SAFETY ALERT

Securing of control system bolts

SA-LTUL-CT__-01;

SA-LTUL-CT2k-01;

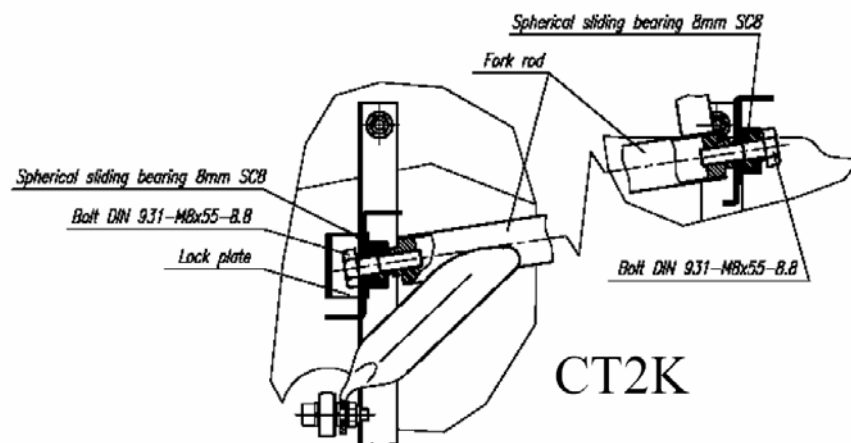
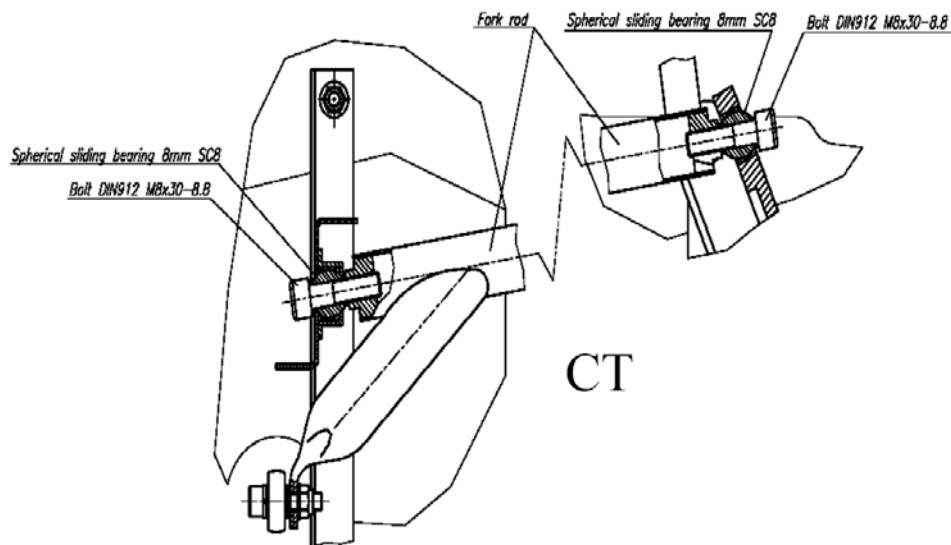
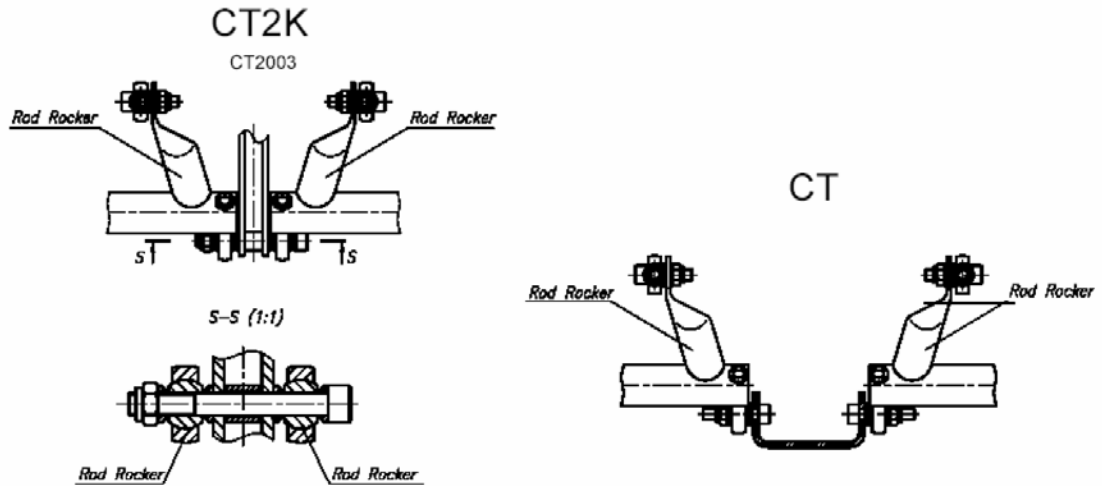
1. Because of corrosion at the CT built 1997 a torsion bearing was sized. Out of this reason the pin in the bearing was loosened and screwed out. First CT2K was built in 2000. Additional lock plates are stipulated.

- It has to be insured that the lubrication of bearing and hinges according the flight & maintenance manual is made accordingly.
- The bearing pins and the flap connecting bolt have to be checked if fixed. If loose, they have to be tightened and secured with loctite (hard) or a safety pin.
- The cables for airbox & heating have to be cut to minimal length

Connection of Rod Rocker

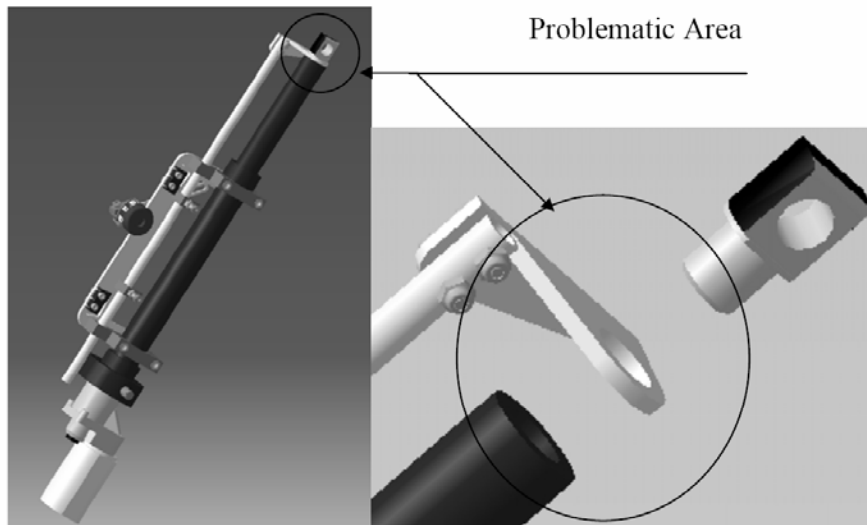
- The CT2K built 2003 the connecting bolt between the none rotating tube at the flap engine and the flaps was screwed out. It was visibly that the bolt was secured with loctite, in trials, even with none secured bolts, this could not be reached.

For fixing of tip a bolt A2 913 4x6 could be used

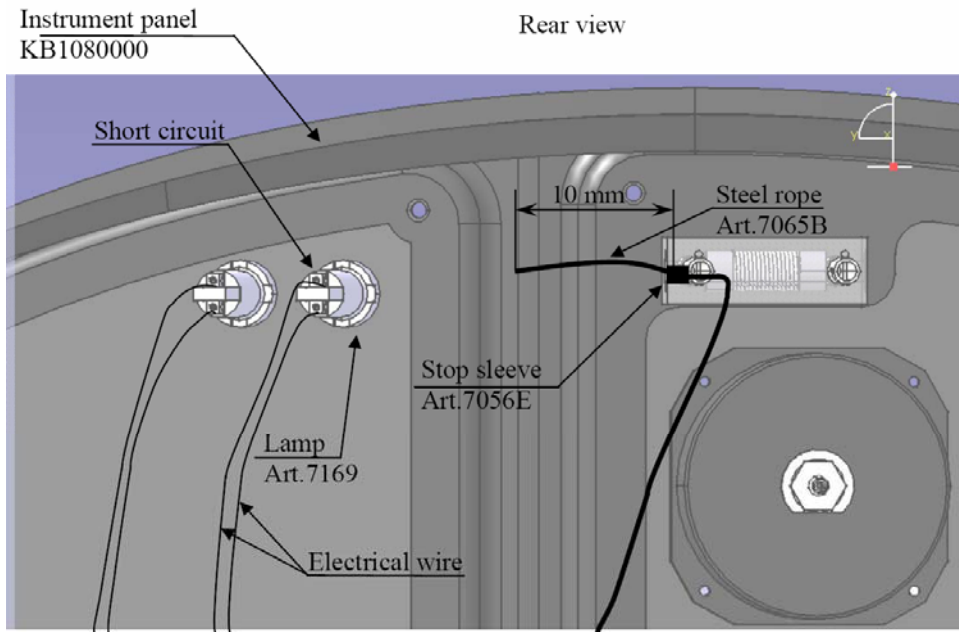
- The CT2K built in 2002 a shortcut was noted during flight. Reason was that the extended cable of the airbox lever has shortcut the warning lamps. To avoid the shortcuts, the free end of the cable must not exceed 10mm. This point has been included into the final check list.
